Model: OP-P1	Date: 14-Dec-12	No.: RM133001a
--------------	-----------------	----------------

RTB Reissue

Subject: Firmware Release Note: Controller		Prepared by: Y. Miyamoto	
From: 1st Tech Service Sect., MFP/Printer Tech Service Dept.			
Classification:	<input type="checkbox"/> Troubleshooting <input type="checkbox"/> Mechanical <input type="checkbox"/> Paper path <input type="checkbox"/> Product Safety	<input type="checkbox"/> Part information <input type="checkbox"/> Electrical <input type="checkbox"/> Transmit/receive <input checked="" type="checkbox"/> Other (Firmware)	<input type="checkbox"/> Action required <input type="checkbox"/> Service manual revision <input type="checkbox"/> Retrofit information <input checked="" type="checkbox"/> Tier 2

Subject: Used toner tank cap Abolished

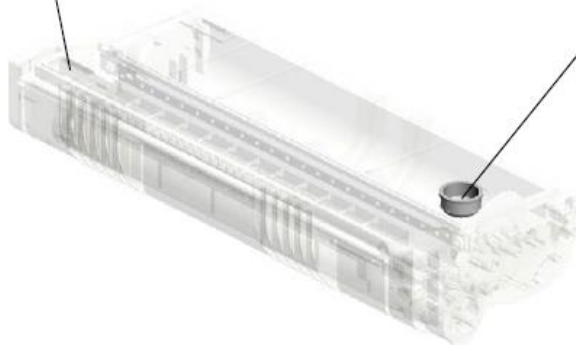
CAP:USED TONER (M1013651) has been abolished since the cartridge doesn't use the toner port anymore.
